Department of Environmental Conservation

DIVISION OF SPILL PREVENTION AND RESPONSE
Contaminated Sites Program

April 11, 2018

RE: Wrangell Monofill Project – CSP2 Report

GROUNDWATER CONTOURS
WRANGELL MONOFILL
WRANGELL ISLAND, ALASKA

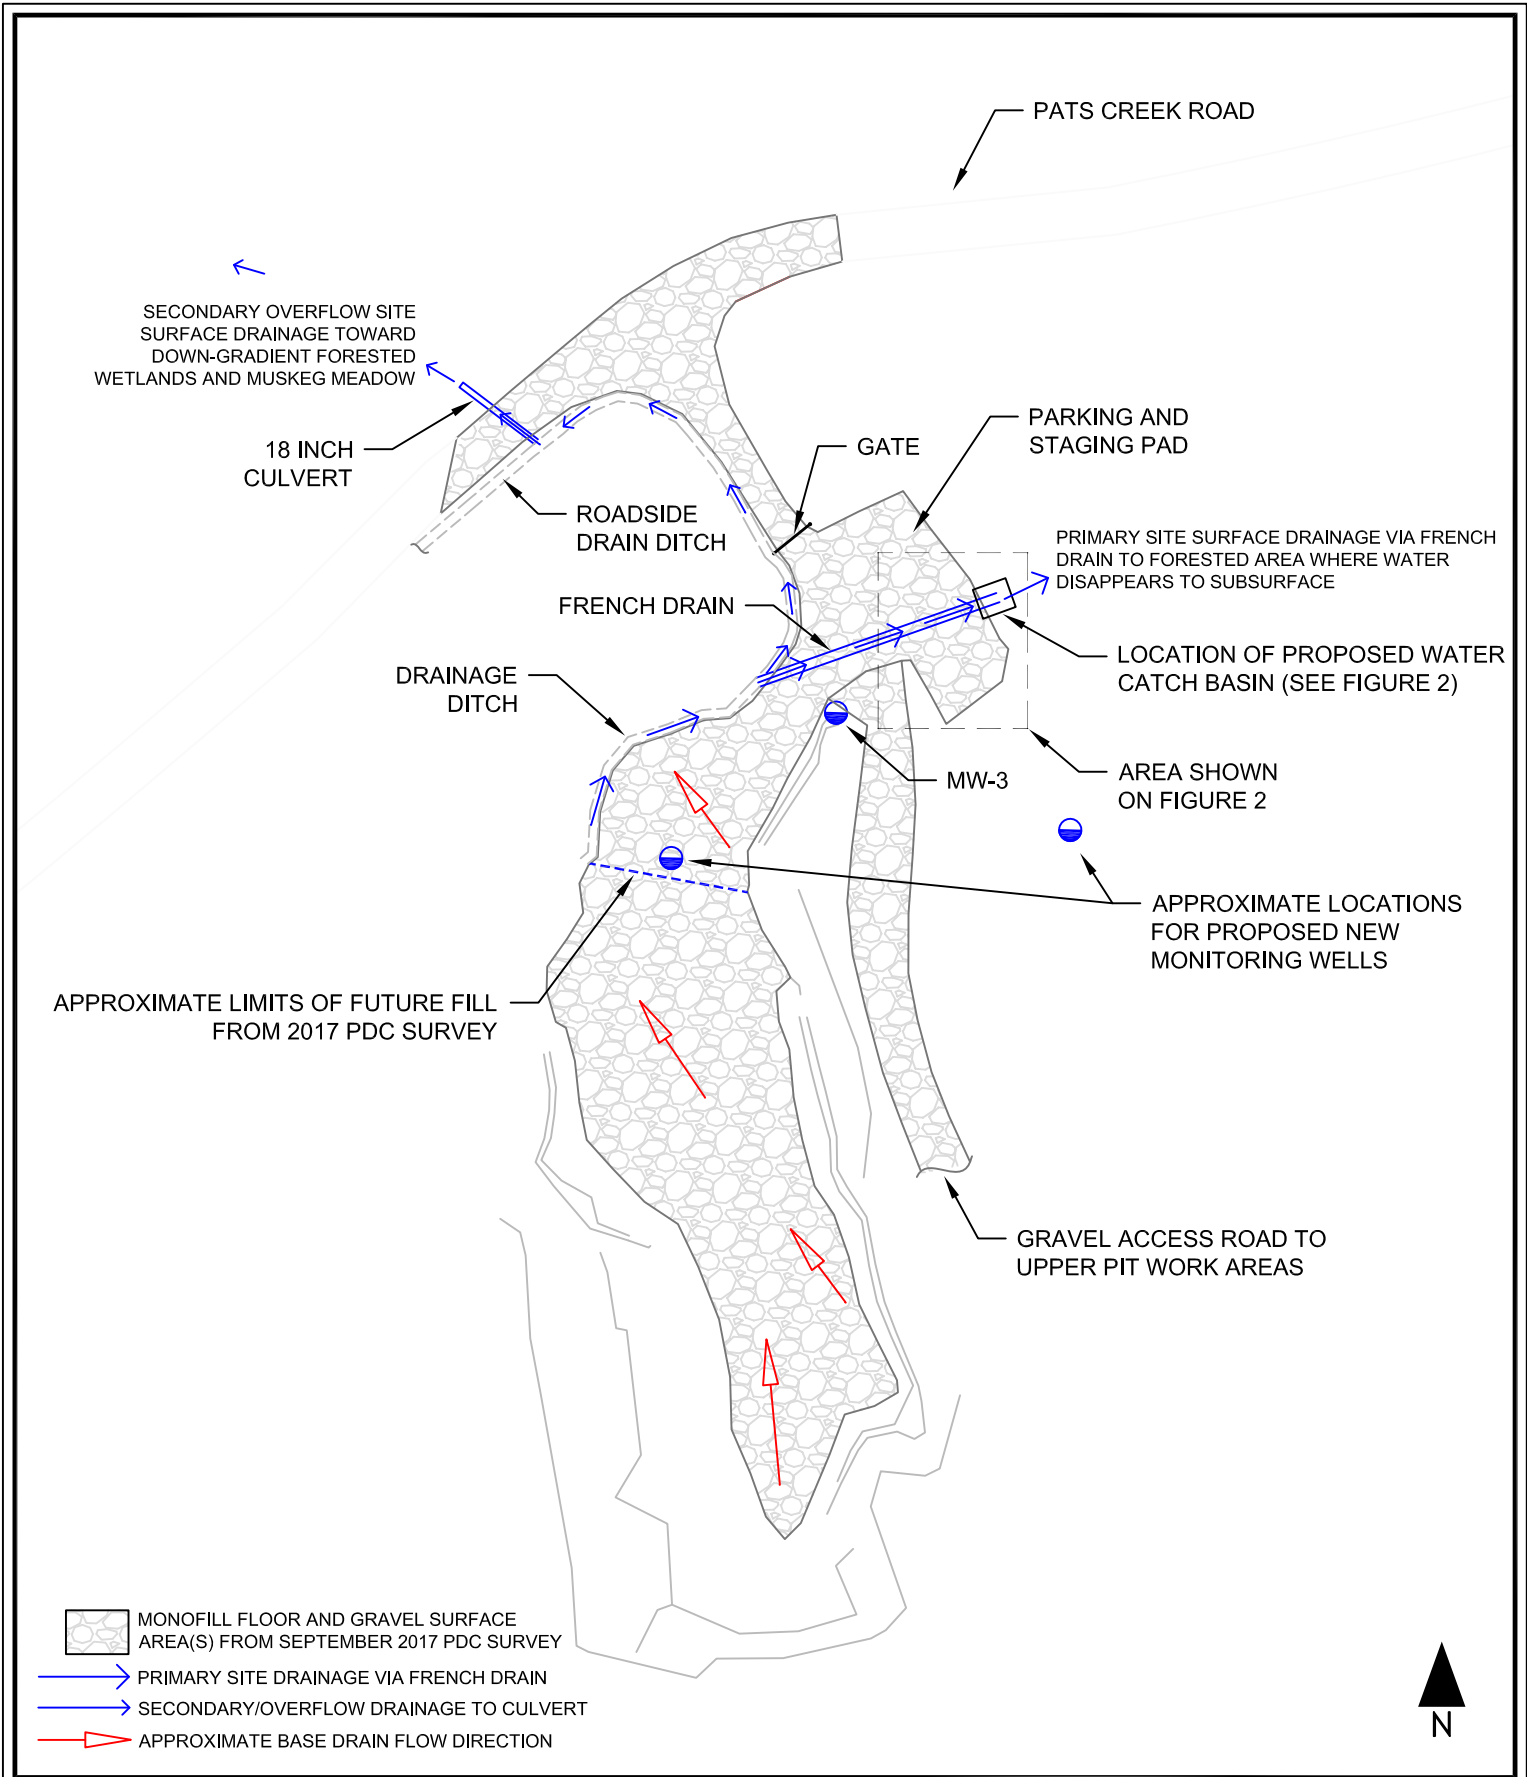
Figures 1 and 3 show surface drainage flows inside the pit and area hydrologic flows. Note that groundwater flow direction (see groundwater contour map) is different from the base layer flow direction. DEC is currently conducting fate and transport modeling in conjunction with the re-evaluation of the HELP Model calculations, based on the concentrations of contaminants detected in the pore water of the stockpile. The DEC will use these concentrations coupled with the annual infiltration rate through the monofill cover design to model the contaminant concentration that may exit the monofill through the drainage base layer and its relationship to regulatory criteria for groundwater and surface water aquatic life.

XVI. CSP2- Verify that the remaining groundwater well is downgradient of the rock pit. Provide a figure showing groundwater contours, including flow direction and depth to groundwater, for the upper aquifer. Describe where the remaining monitoring well intersects this aquifer, and whether it intersects it during all periods of the year so that quarterly groundwater monitoring can be conducted. Install a new well if necessary.

Attached is the groundwater contour map developed by Ahtna as part of their 2016 study of the pit. It clearly shows that the remaining groundwater well is sited hydrologically downgradient of the pit. In addition, DEC has installed a data logger on the well to report groundwater elevations. Once the monofill is constructed, DEC will install a second well at the toe of the monofill, and a third “control” or background monitoring well located on the east side of the parking area. A fourth well may be proposed for installation between the road and the creek.

Monofill French Drain and Catch Basin Diagrams
 Construction of Solid Waste Monofill for Lead Contaminated Soil
 ADEC AR Term Contract 18-70020-01
 Pat's Creek Rd, DNR Rock Pit #2 Wrangell, Alaska 99929

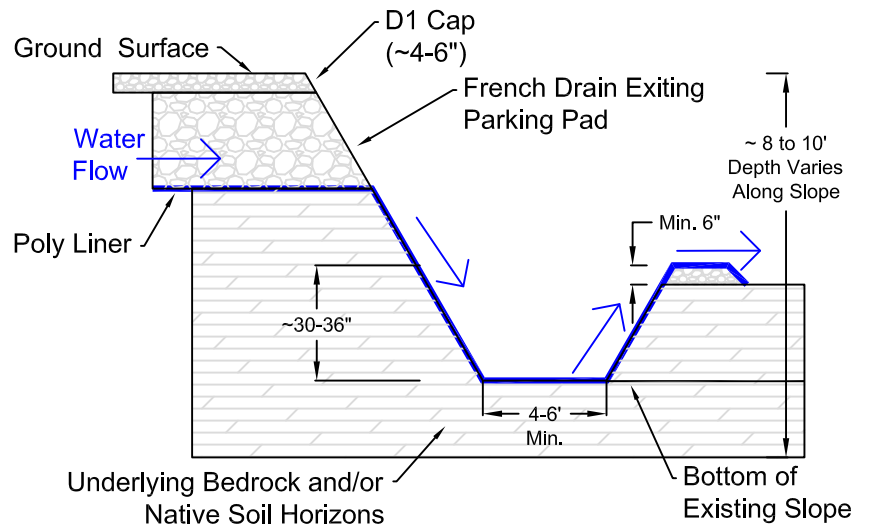
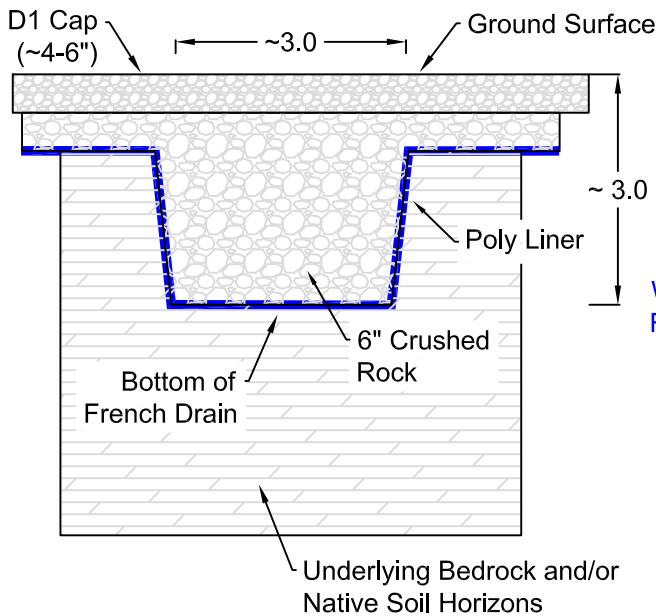
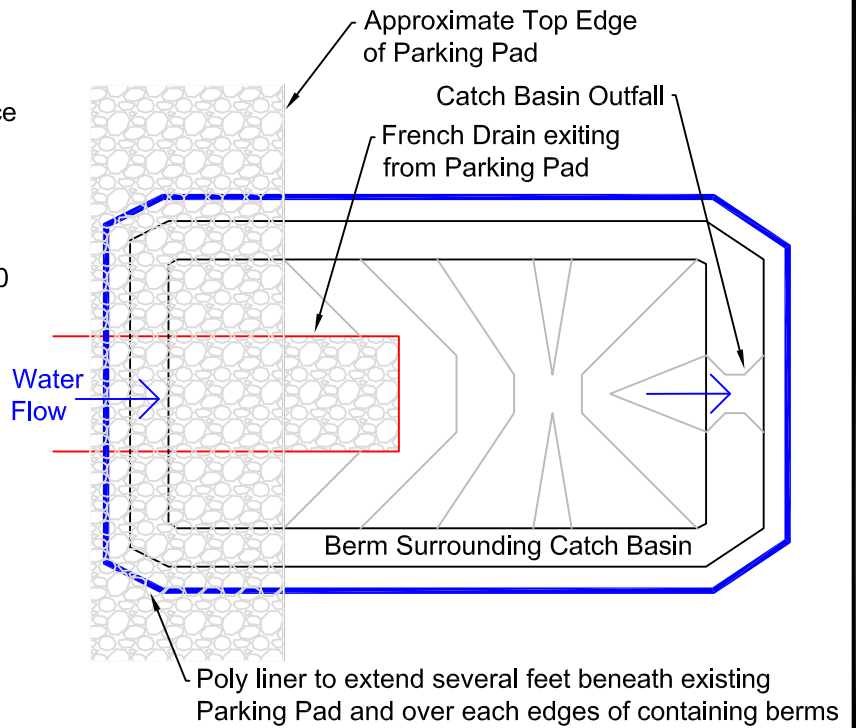
XIV. CSP2- Provide mitigation options to control, treat, or divert seepage if contaminant levels increase at testing locations.

DEC will install a catch basin at or near the discharge point of the French drain system. This system is shown on Figure 2. It measures approximately three feet wide, 1.5-2.5 feet deep, and approximately 65 feet in length. This system drains nearly 100% of the stormwater and surface water from the pit. The roadside drainage only collects surface water from the east side of the parking area and the driveway to the pit. Therefore, monitoring the discharge point (catch basin) of the French drain system, is proposed for once during each storm event of >1" precipitation and not

less than once a week during a sustained precipitation event, and analyzing surface water samples for dissolved and total lead will provide worst-case conditions. If water shows evidence of lead above area background concentrations for surface water, the DEC will install a passive bioreactor with zeolite or other treatment system to treat the water during construction and if necessary, after construction. Figure 3 shows hydrologic flow pathways from the rock pit to the closest downgradient surface water tributary. However, water discharging from the French drain disappears almost immediately into the ground to the northeast of the parking pad.

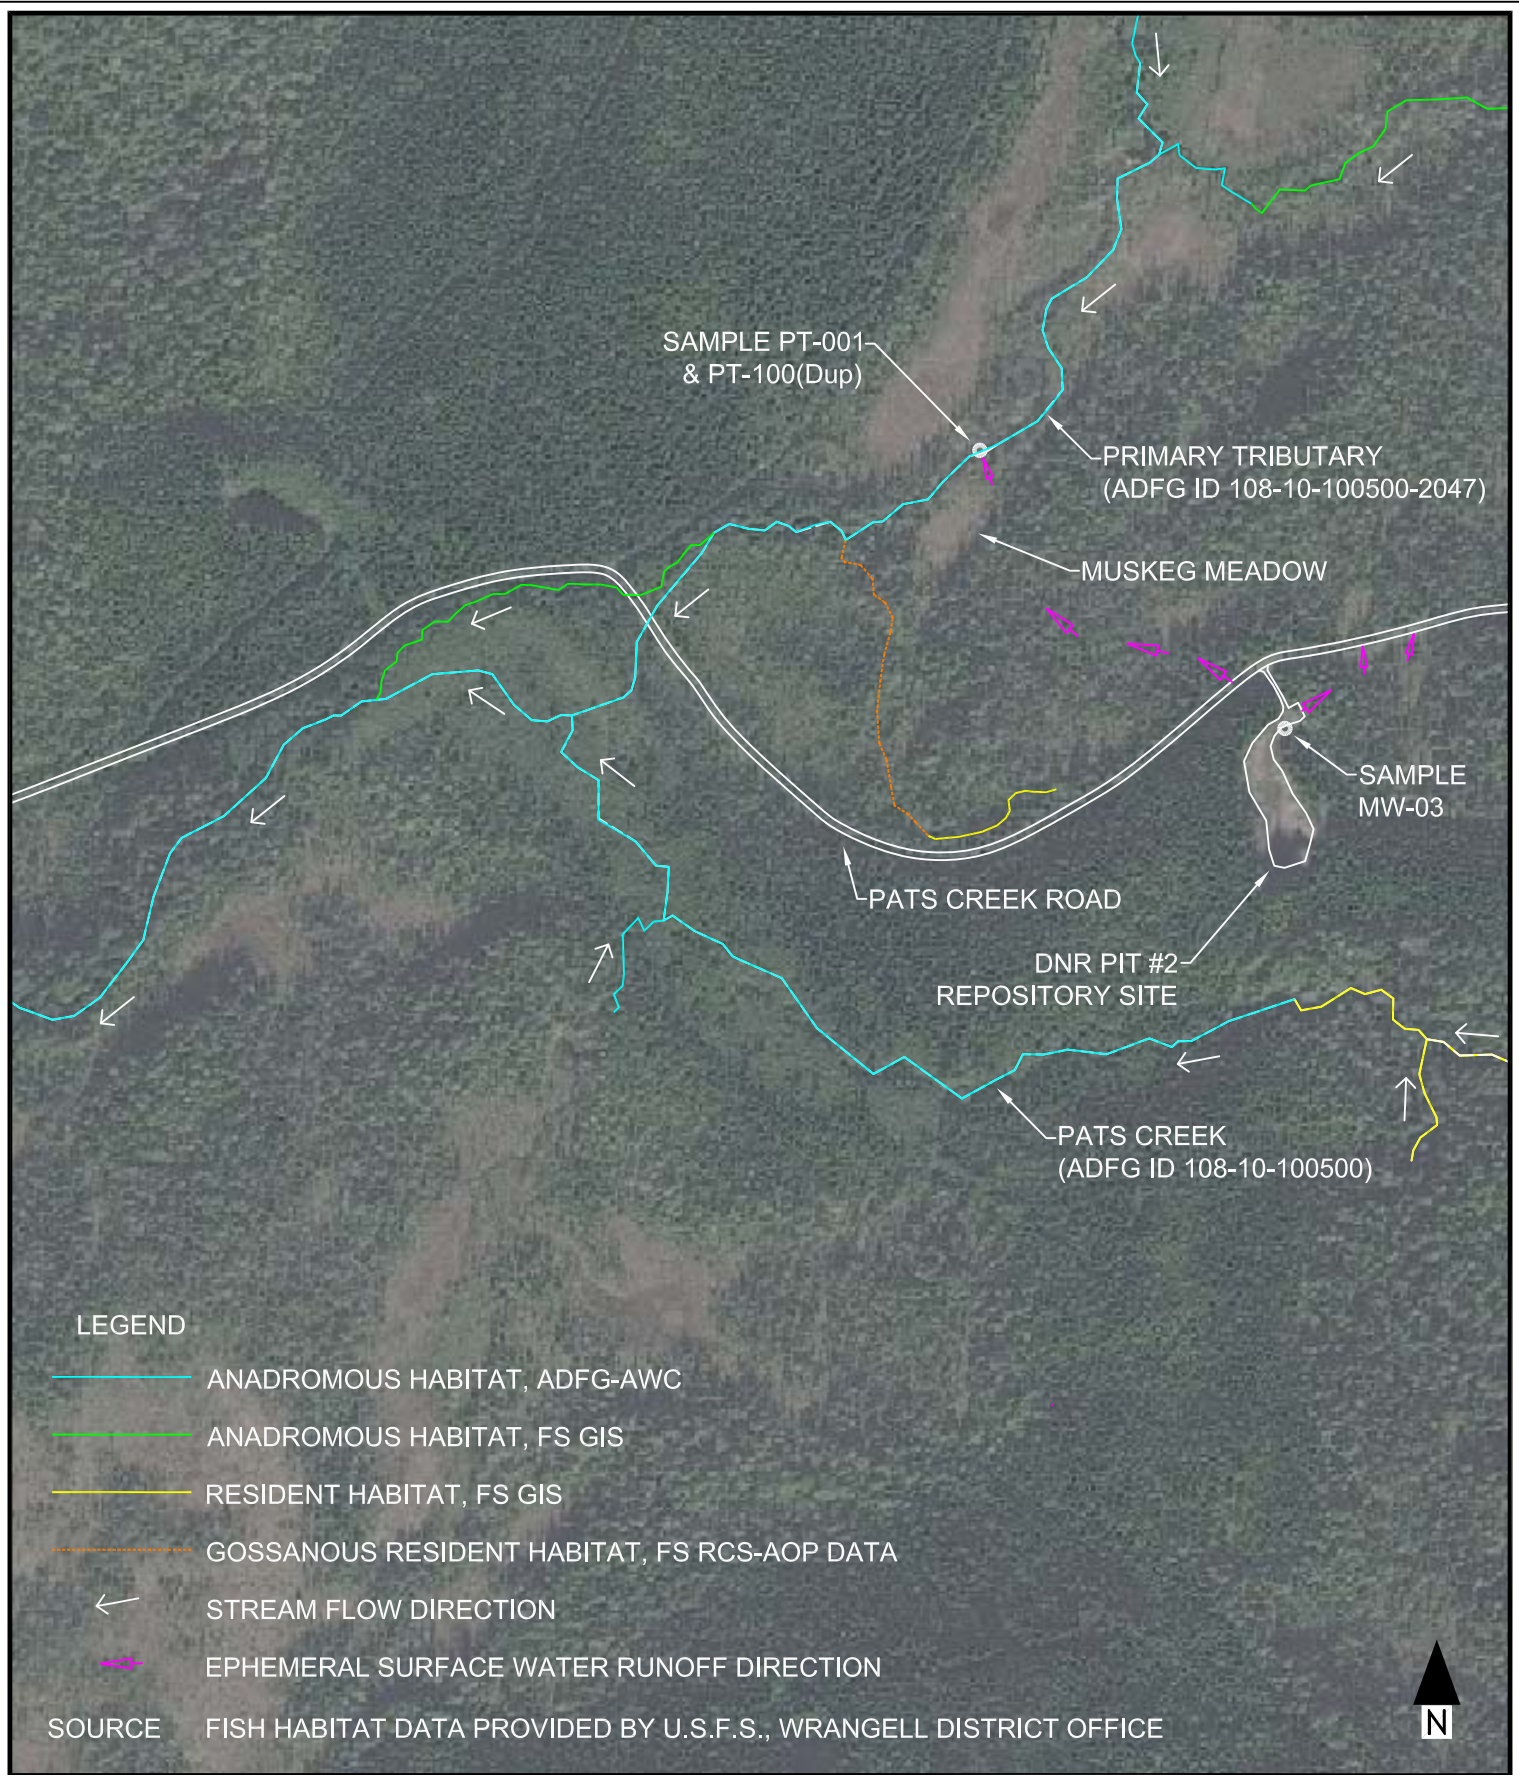
XIII. CSP2- conduct more evaluation on potential impacts to aquatic life
